Meeting of the
Scotts Valley City Council
In-Person and Remote Access
Date: October 2, 2024
Time: 6:00 PM

The proposed project includes demolition of the existing commercial buildings and construction of a three-story commercial redevelopment which consists of one 52,822 square feet (sf) building (Attachment 2: Sheet A2.1 Site Plan). This building would include 10,465 square feet of professional and administrative office space, and 42,357 square feet of storage for up to 227 user spaces. The first and second floors of the building will be bifurcated by an internal drive aisle that allows vehicles to park for loading and unloading. The third floor will be continuous over the internal drive aisle. There will be three office spaces on the first floor, six office spaces on the second floor and six office spaces on the third floor, although it is important to note that while Sheet A2.2 of the plan set shows a total of 13 office/storage spaces, the project, as proposed, would allow the applicant to demise the interior space into 227 individual storage spaces, if desired. The project would provide 54 parking spaces located on the north and south extents of the project site, and along a c

REVISIONS		BY
1	Planning Comments	TC
10-6-23		
LIGHTING PLAN		
BETHANY PROFESSIONAL PROP. 125 BETHANT DRIVE SCOTT'S VALLEY, CALIFORNIA		
Date:	10-06-23	
	1" = 20'	
Drawn:	TC/JB	
Job:	338-40	
Sheet:	E1	
Of	1 Sheets

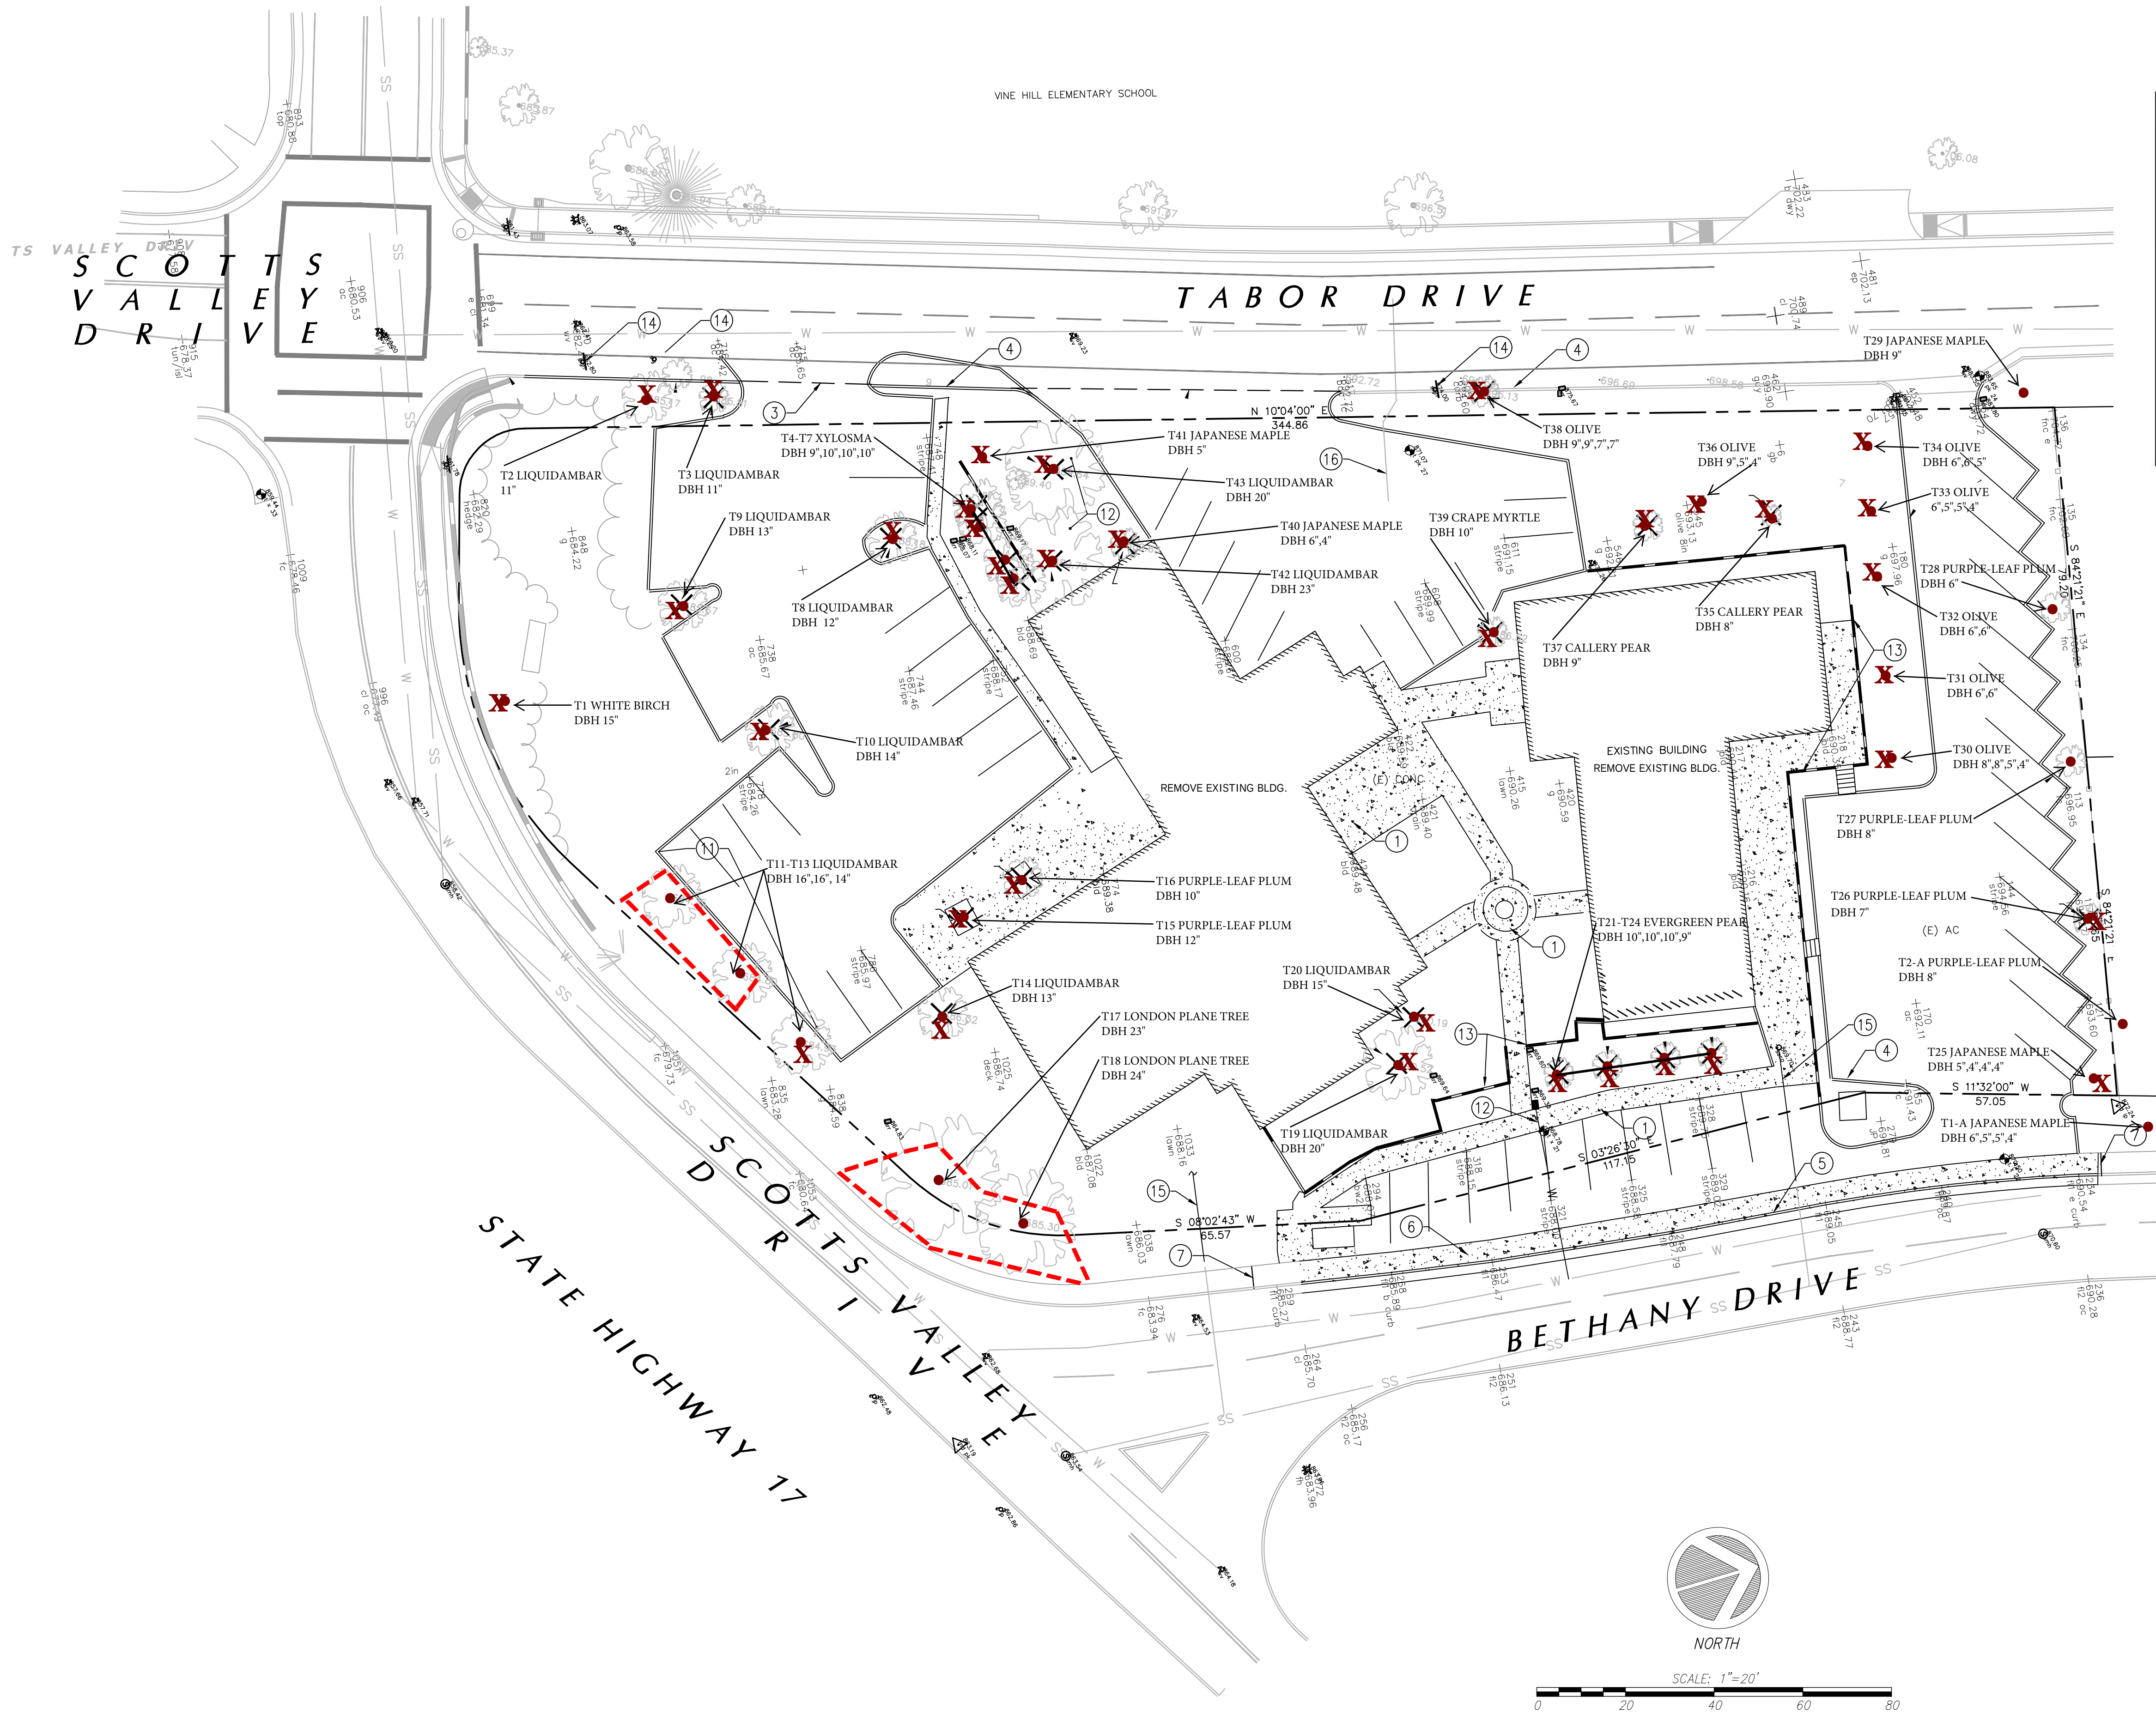
The Planning Department has concerns about one of the free-standing light fixtures located at the rear of the project site, adjacent to the residential uses where the photometric plan shows light leak to the adjacent property (Attachment 1: Sheet E1). If approved, the project would include a condition of approval that would require all lighting footprints to be fully contained on site.
